WATER PERMIT NO. FC39-3

SOUTH DAKOTA FLOOD CONTROL PERMIT NO. FC39-3

The Chief Engineer, on behalf of the Water Management Board, issues Flood Control Permit No. FC39-3 to Upper Minnesota River Watershed District, 211 2nd Street SE, Ortonville MN 56278, subject to the following limitations, conditions and qualifications:

30% PRELIMINARY DESIGN PLANS FOR UPPER MINNESOTA RIVER WATERSHED DISTRICT WHETSTONE RIVER RESTORATION

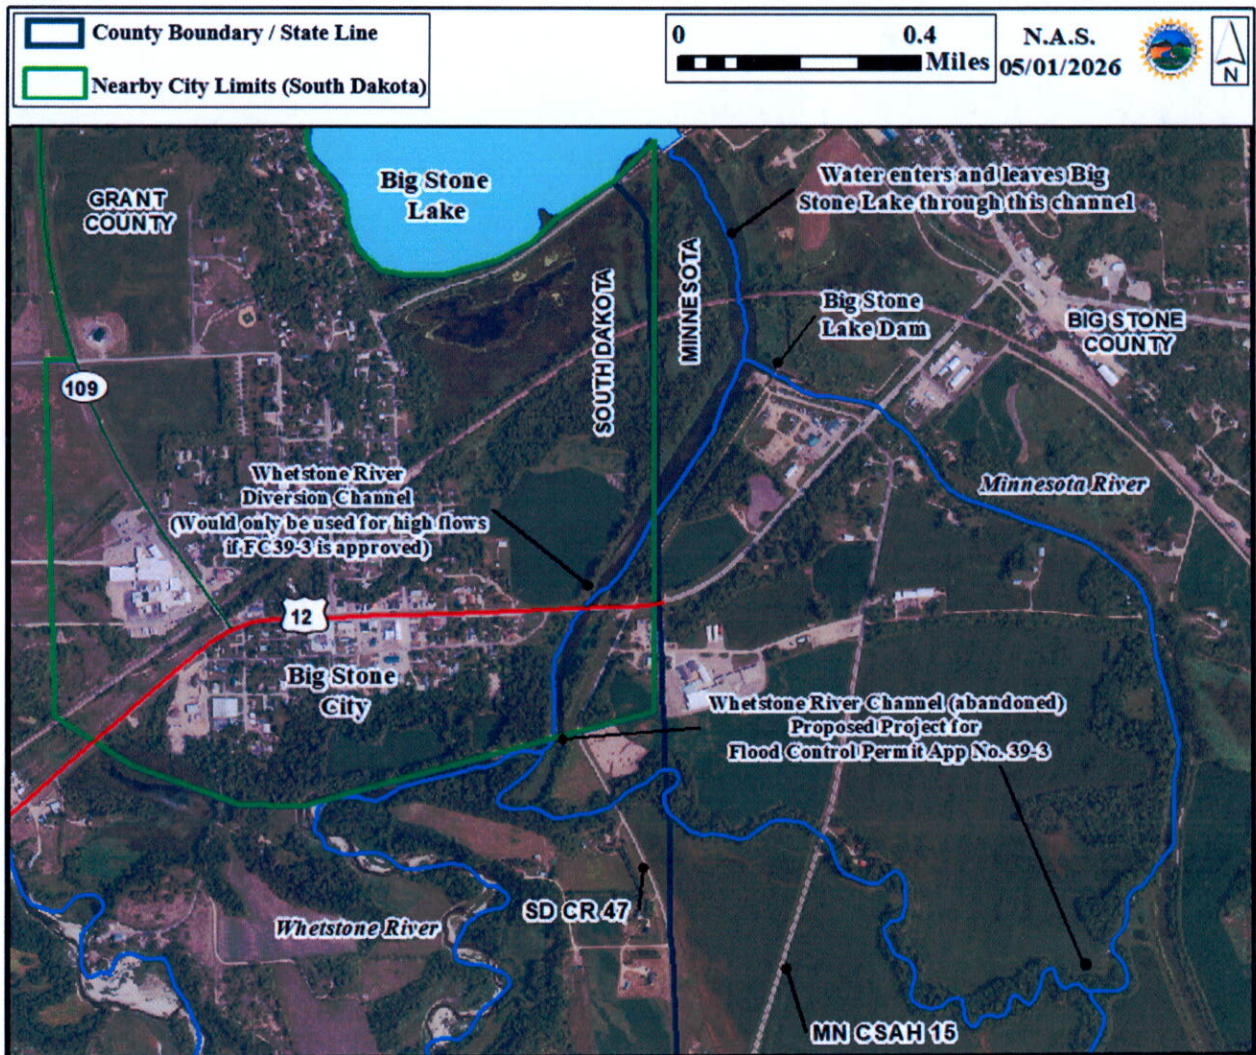
Figure 1 displays the site of interest for Flood Control Permit Application No. FC39-3 including the channel that currently diverts water into Big Stone Lake, the dam structure that controls discharges from the lake into the Minnesota River, and the historic Whetstone River channel proposed to be restored (modified from Deutshman and Odens, 2015). Mapped data for roads and cities was only available for SD. A more detailed map is provided in Appendix A.

This engineering analysis submitted with this report proposes adding a weir in the diversion channel (downstream of the confluence with the historic channel), adding an inlet weir (at the confluence of the diversion and historic channels), excavating the embankment that currently blocks diversion channel flow from entering historic channel, floodplain construction along the historic channel, widening the bridge crossing at SD County Road (CR) 47, removing the MN County and State Highway (CSAH) 15 crossing (to reduce runoff and improve connectivity between the Whetstone and Minnesota Rivers), adding business and residential levees (protected up to 1% chance exceedance per year) and agricultural levees (protected up to 10% chance exceedance per year), modifying transportation features by raising and improving CR47, removing vegetation to improve lateral connectivity, and restoring native plants (Deutshman and Odens, 2015). Locations of these proposed components to restore flow back to the historic channel are displayed in Appendix B (modified from Deutshman and Odens, 2015).

Figure 2. One percent chance exceedance per year flood inundation extent produced by Houston Engineering (Deutschman and Odens, 2015) with and without the effects of the project proposed for Flood Control Permit Application No. FC39-3

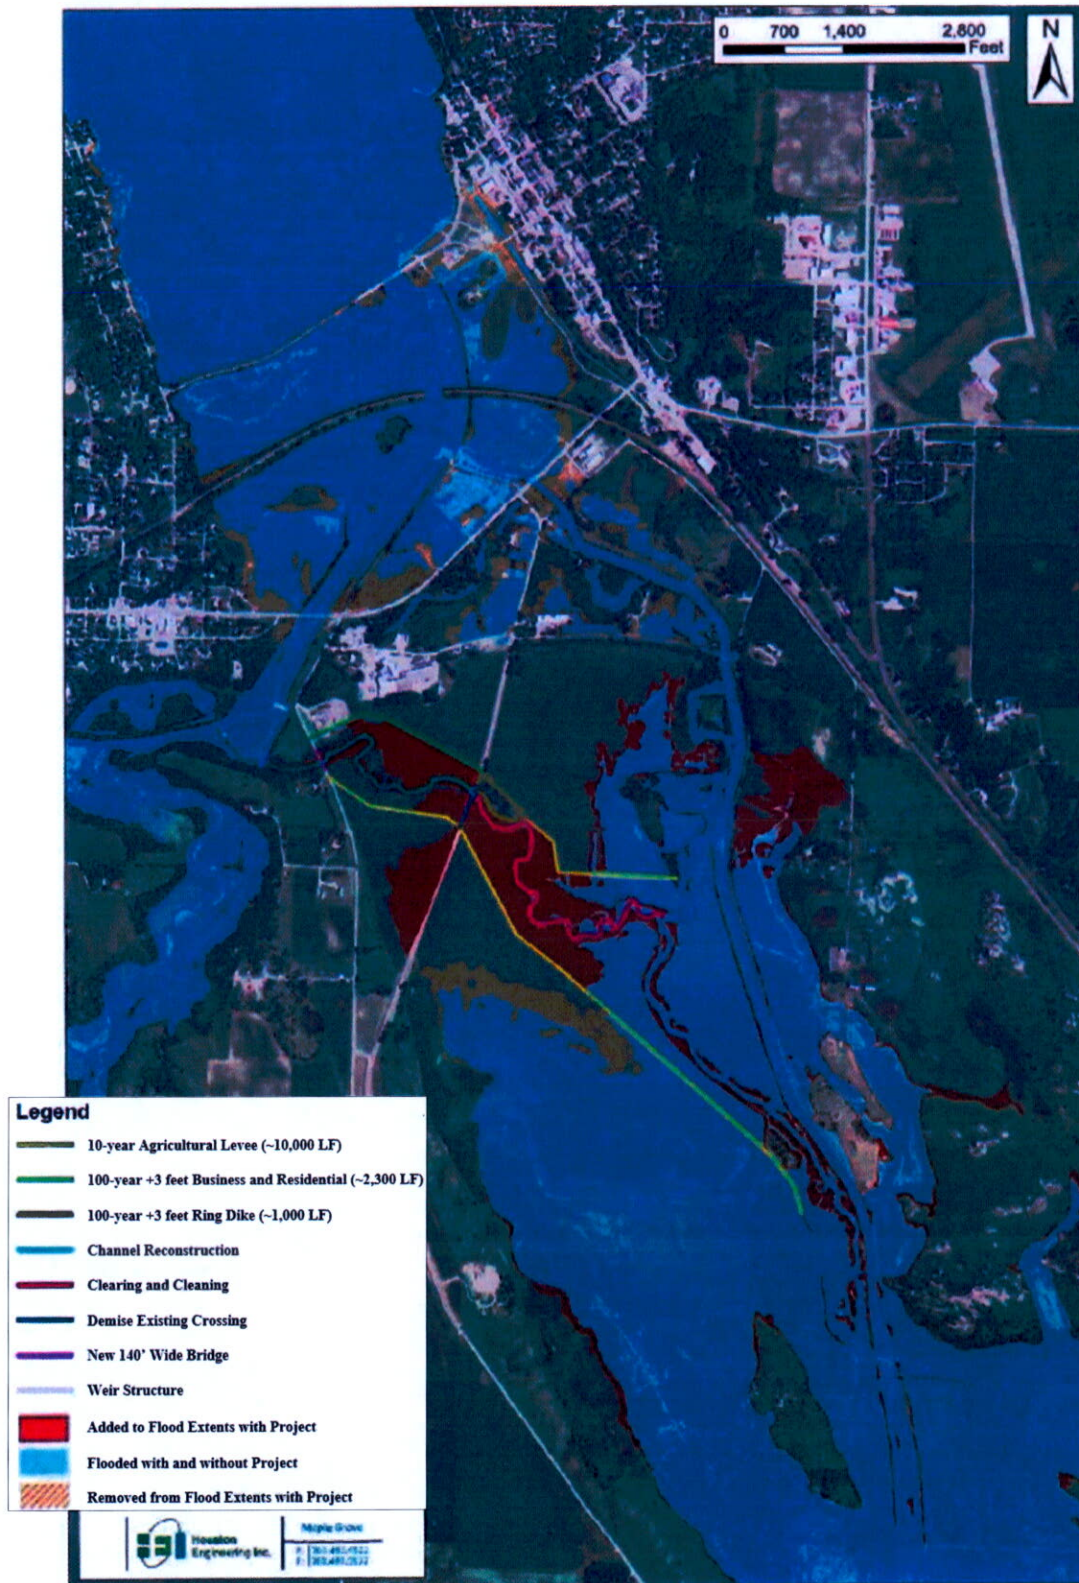
The next qualification pursuant to SDCL 46-2A-11 states the project cannot increase the likelihood or the severity of flood damage in areas other than the project area or the area proposed to be benefited. Figure 2 displays the flood inundation map produced by Houston Engineering that depicts the 100-year flood inundation extent with and without the effects of the proposed project for Flood Control Permit Application No. FC39-3. The blue inundation shown on the map in Figure 2 displays what would be flooded with or without the changes proposed in this application, during the 100-year flood event. The red inundation shown on the map in Figure 2 displays what lands would be flooded during the 100-year flood event with the restoration of the historic channel. The additional flooding expected with the project appears to be negligible in relation to what would already be flooded without the modifications. Design plans indicated purchasing flood easements for newly inundated areas during the 1% per year chance exceedance per year flood event to offset adverse flooding impacts in these areas. Floodplain maps will need to be updated and submitted to FEMA following construction (Deutshman and Odens, 2015).

Reconnecting the historic channel to the Minnesota River will alter the timing and routing of flows that currently enter Big Stone Lake; thus, modestly increasing peak downstream discharge rates to downstream flood control systems and federal infrastructure. As part of the USACE Section 408 permitting, which is a permission that is required to modify, alter, or occupy any USACE-constructed civil works project, such as levees, dams, or navigation channels, a hydrologic and hydraulic (H&H) assessment was conducted to evaluate potential impacts to downstream flood control systems and federal infrastructure. Federal flood control projects downstream of the site of interest include the Highway 75 Dam and reservoir, Lac qui Parle Dam and Reservoir, Marsh Lake Reservoir, the Montevideo Levee System, and Granite Falls Flood Protection. From 2021 to 2025, the UMRWD has been coordinating with USACE to ensure the modeling, assumptions, and evaluation metrics meet federal framework. These modeling efforts are summarized in Odens (2025), included in the application submittal. On February 12, 2024, the USACE formally concluded that the project does not result in injurious impacts to federal reservoirs and the 408 authorization is limited to a technical review process on the H&H impacts (Deutshman and Odens, 2015; Odens, 2025; Houston Engineering, 2026). Odens (2025) additionally indicated that Houston and UMRWD are already coordinating with FEMA and MN DNR on any needed updates to floodplain maps, expected as a part of this project.

9. To uphold the criteria set forth in SDCL 46-2A-11, the following qualifications are recommended if this application is approved:
 - a. The permit holder is responsible for operation and maintenance of the flood control works.
 - b. If approved, the Water Management Board retains jurisdiction of Flood Control Permit No. FC39-3 in the event that conditions change that would affect the permit qualifications.
 - c. Operation of the flood control structures may not impair management of Big Stone Lake by the U.S. Army Corps of Engineers.
